Section 7.4 It is accepted that the predictive BMV map is for strategic planning purposes, however online maps published by Natural England clearly show the land on either side of Beck Rd (Fields E05 and EC01) are predominantly Grade 2 land This mapping, displayed at a scale smaller than 1:250,000 is based on survey data intended for use at 1:10,000 scale

DBSC picture App-115

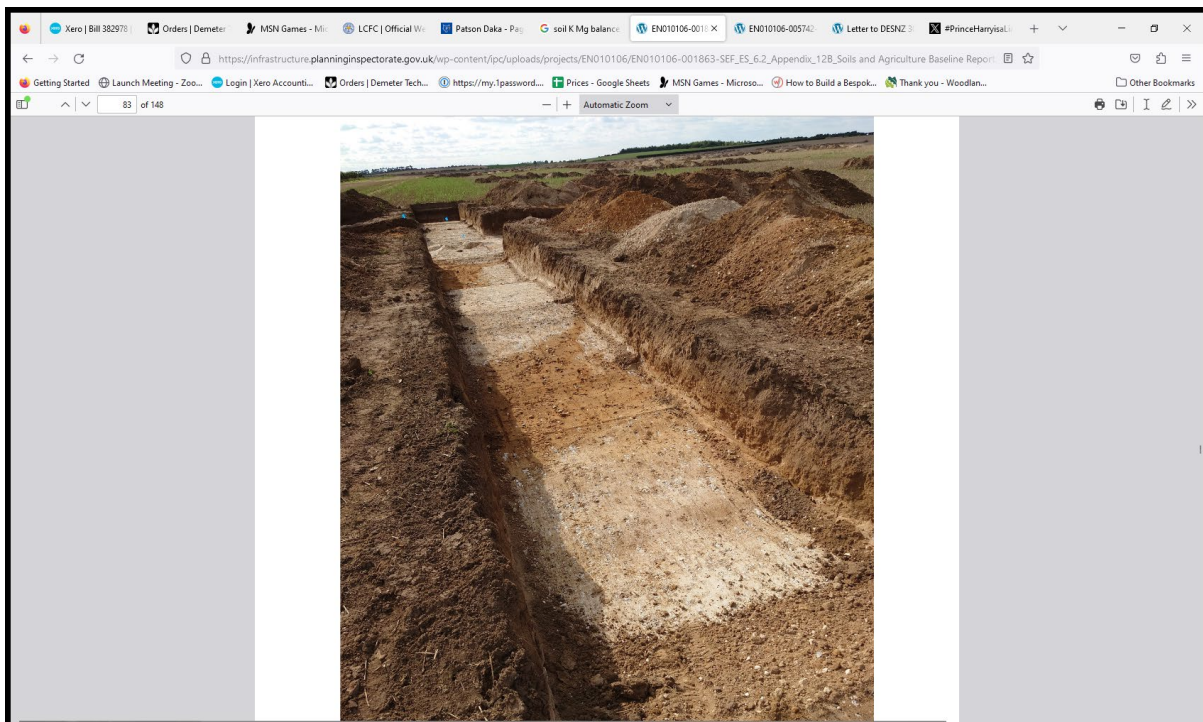
Has detailed soil pit information showing horizon depths, colours and textures been provided? DBSC have used photographs of archaeological trenches (seemingly dug earlier in the season and not representative of the site) to illustrate the soil profiles rather than photographs of the actual pits referred to by DBSC. **FAIL**

DBSC includes pictures of two trenches on Lee Farm and dated Sept 21. There are no grid or other references to identify which fields these trenches were located. Oxford Archaeology (APP-075) include 28 pictures of archaeological trenches in their report. None of these pictures is identical to the pictures used by DBSC, however in several a layer of chalk can clearly be seen lying above further layers of soil. For DBSC to claim that the two trench pictures he presents are typical of the fields is highly misleading. Pits should be dug to a depth of 1.2m.

Oxford Archaeology detail methods used in the trenching. The photos used by DBSC would appear to show the initial machine opening of the trenches with relatively level removal of the top layer, these were then further excavated
